TRANSMITTAL LETTER

Publication 72M
 June 2010 Edition Change #4

**Revisions to
Standards for Roadway Construction
June 2010 Edition, Change No. 4**

BURIED-IN-BACKSLOPE TERMINAL
END ANCHORAGE DETAILS

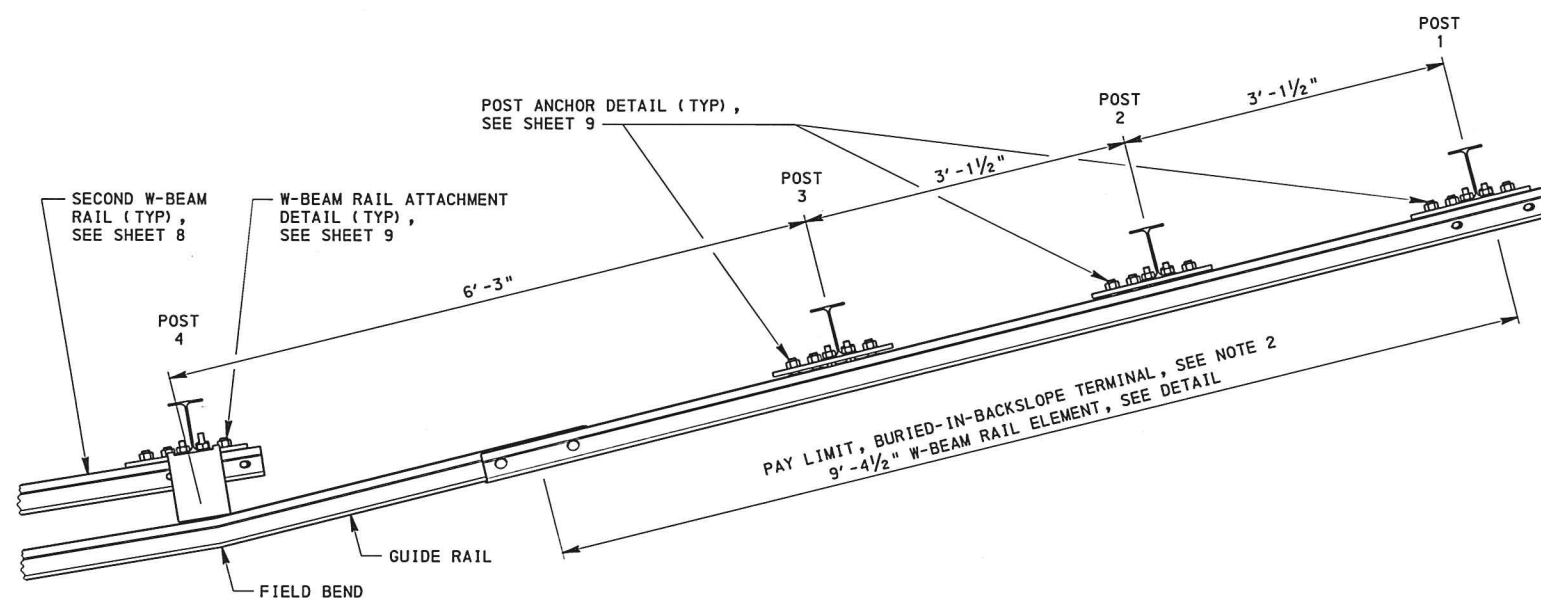
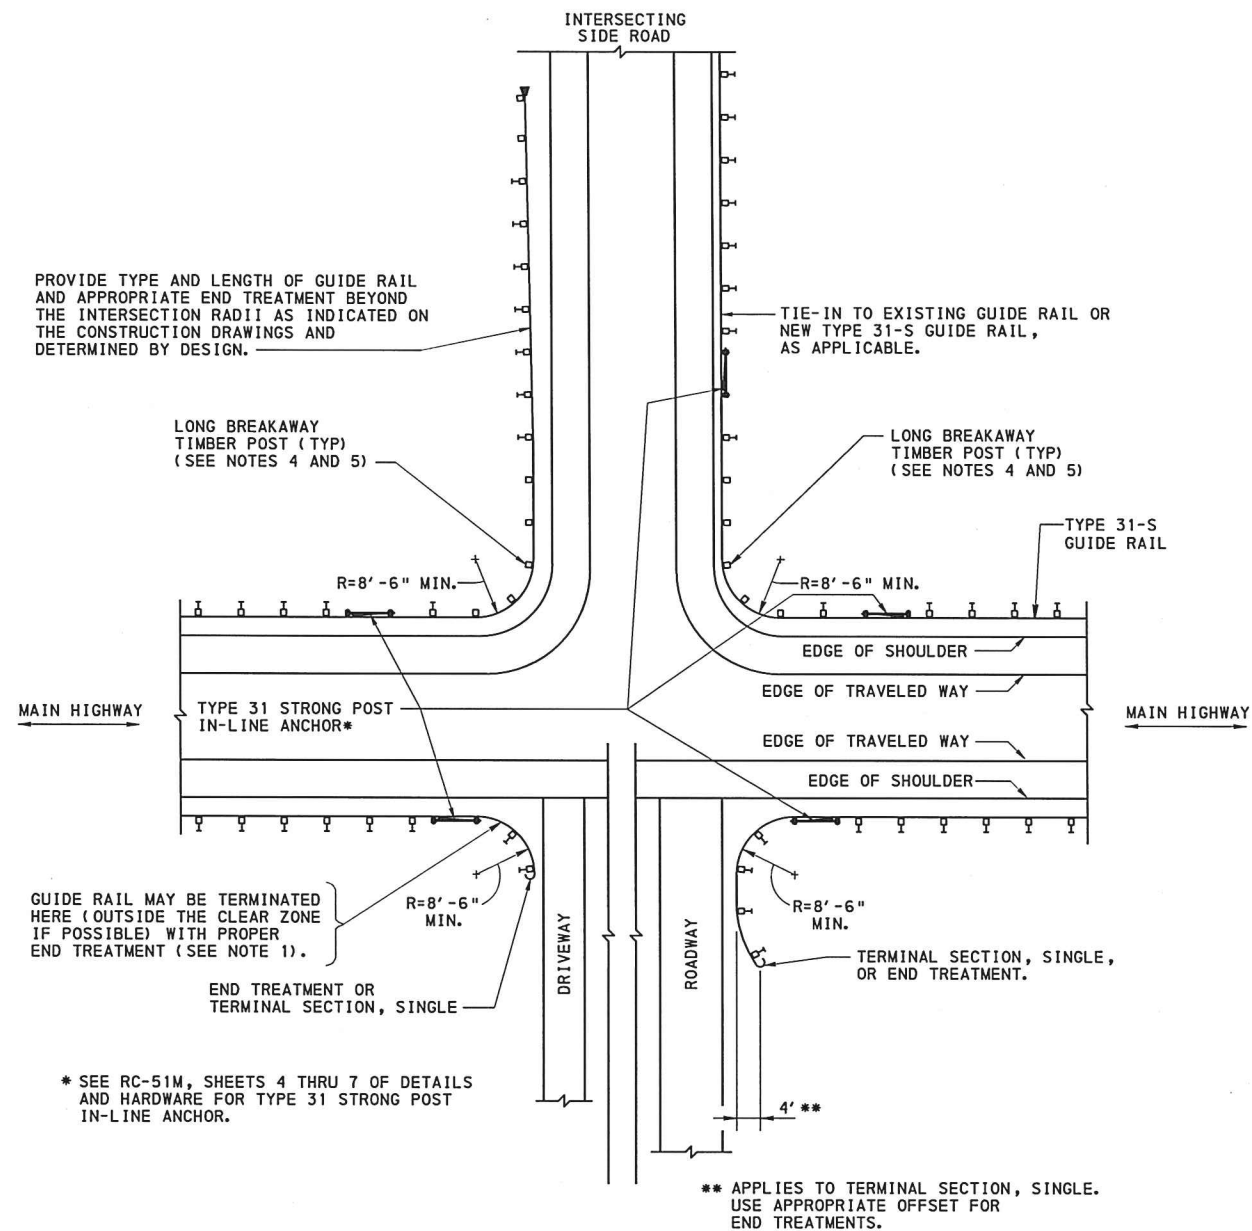
Added End Anchorage Details to be consistent with the test report, *MASH Tests 3-34 and 3-35 on the 31-Inch Buried-in-Backslope Terminal Compatible with MGS Guardrail*, including 9'-4 1/2" W-beam Rail Element, Detail "L", Detail "M", and Detail "N".

Added Note 2 pertaining to pay limit for Buried-in-Backslope Terminal.
